ADDENDUM NUMBER 2

PROJECT | Nanuet Union Free School District  
Nanuet 2020 Miller Hydronic Conversion

PROJECT NUMBER | 1911002.00 Delta Engineers Number 2019.229.001

Date | 4/6/2021

MES-M124

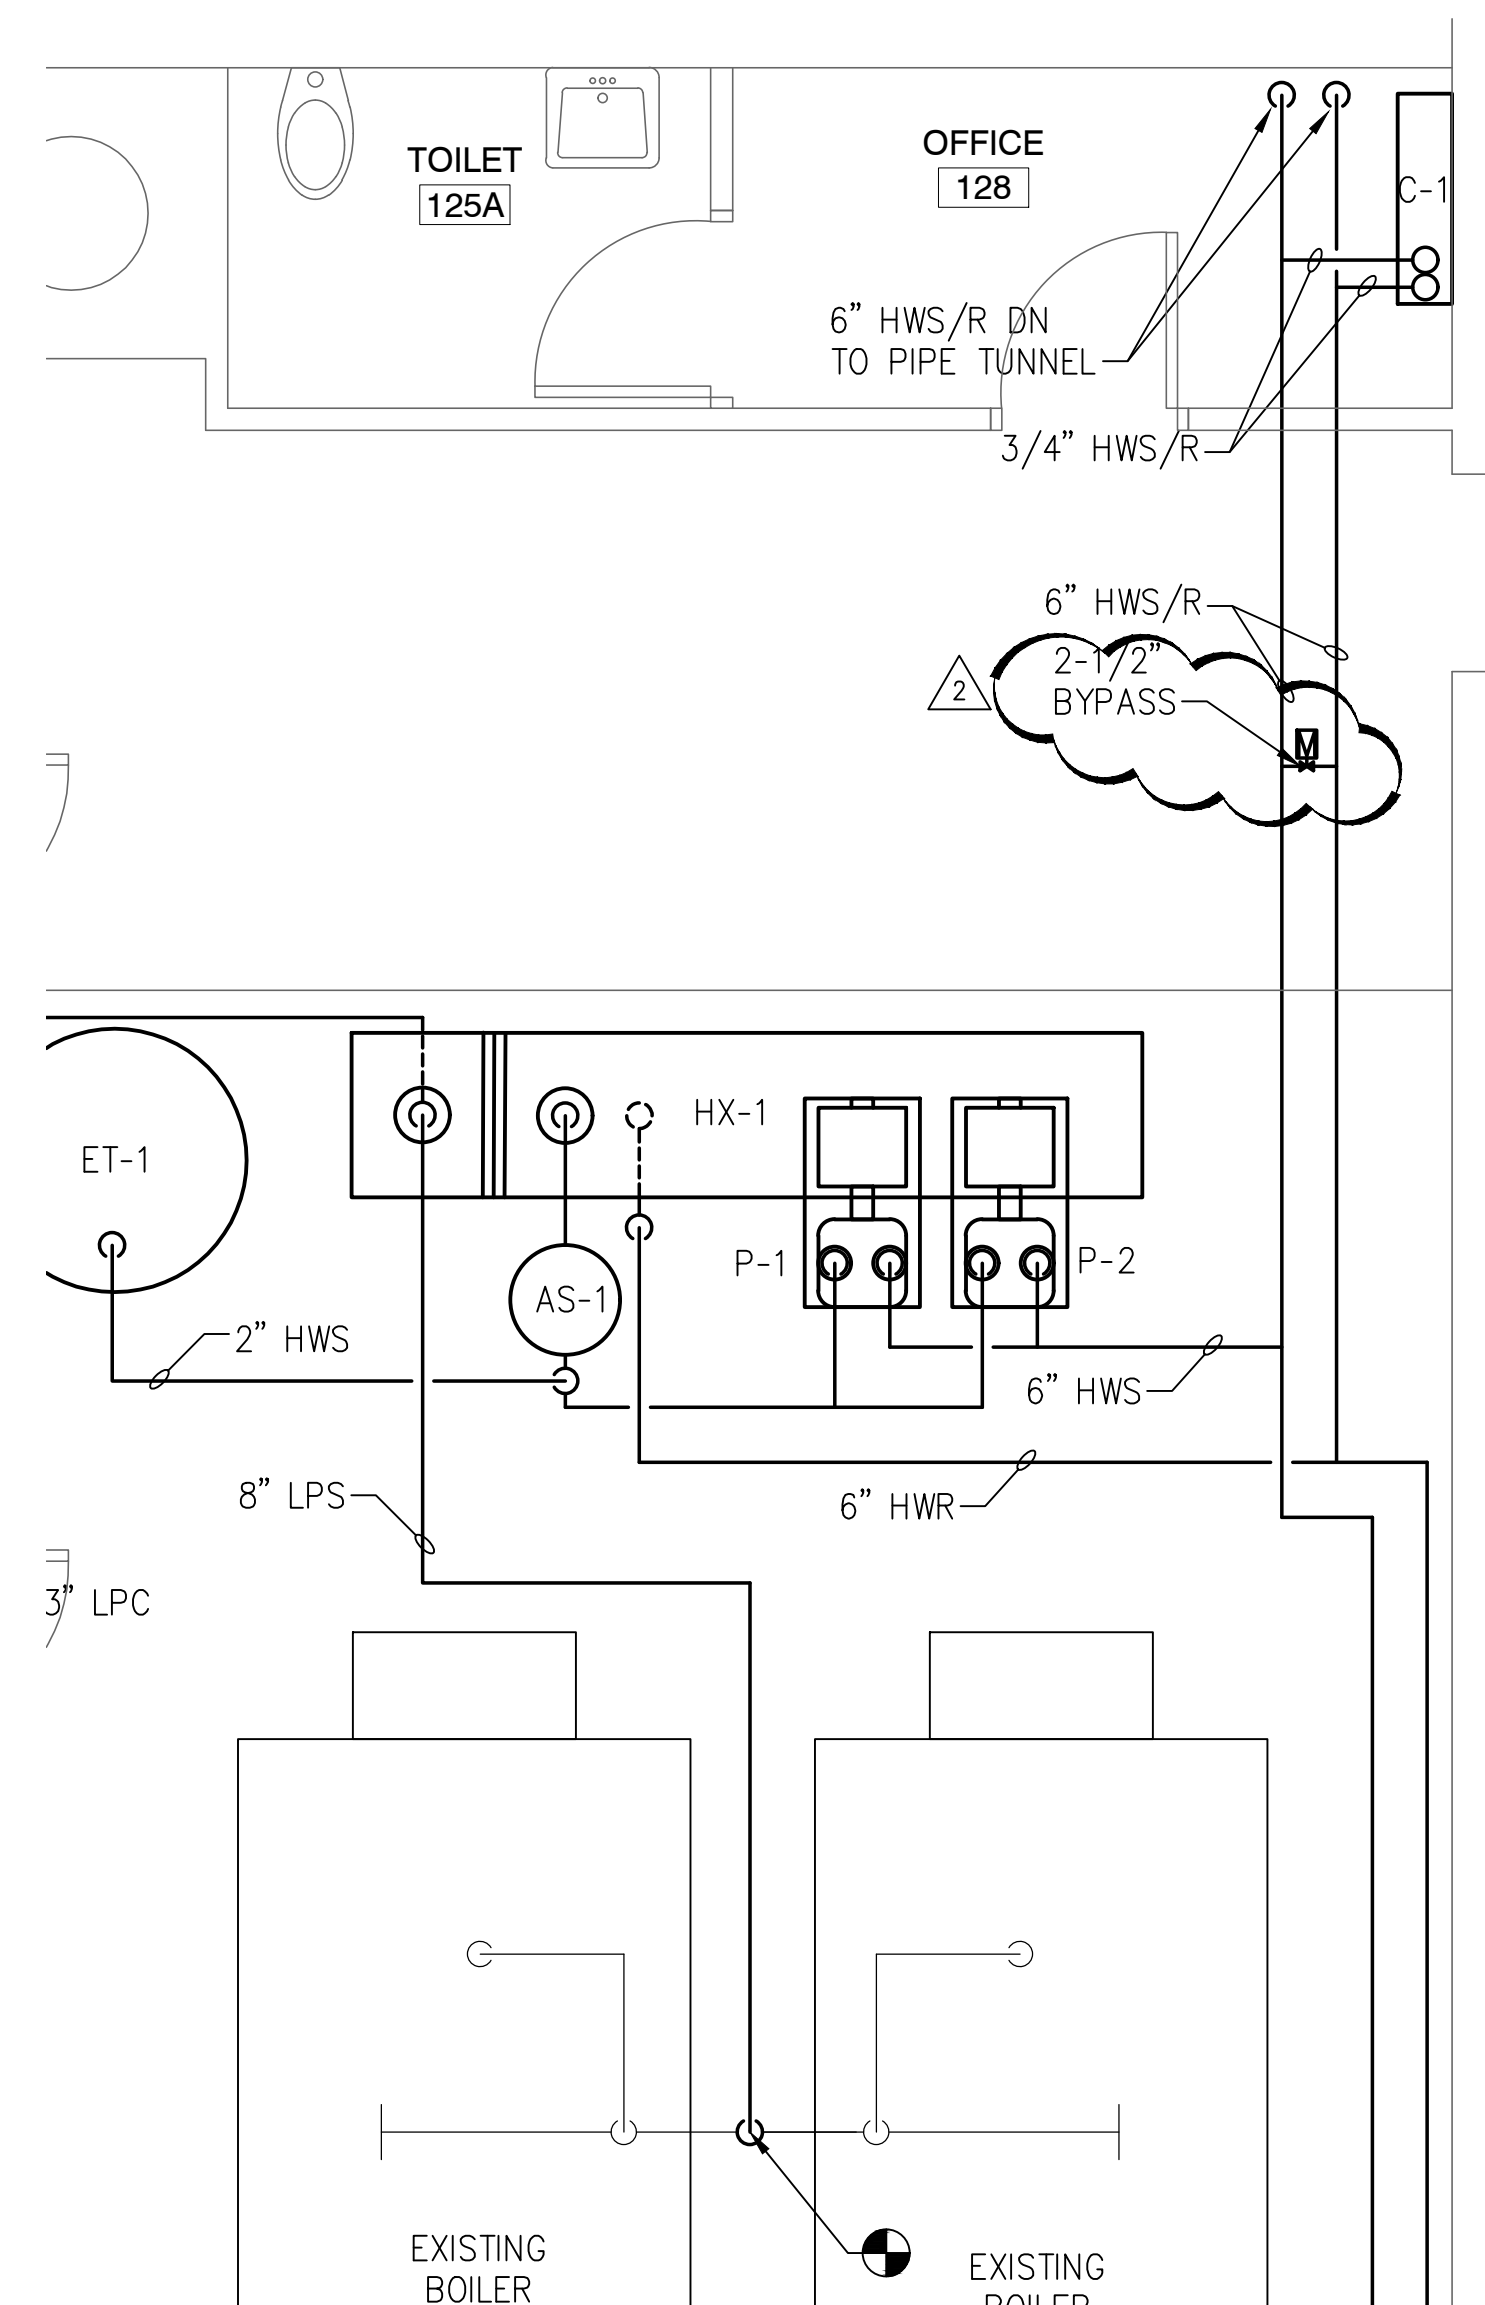
Sheets MES-M124, M501 & M701

- a. Sheets Reissued
- b. Added minimum flow bypass.
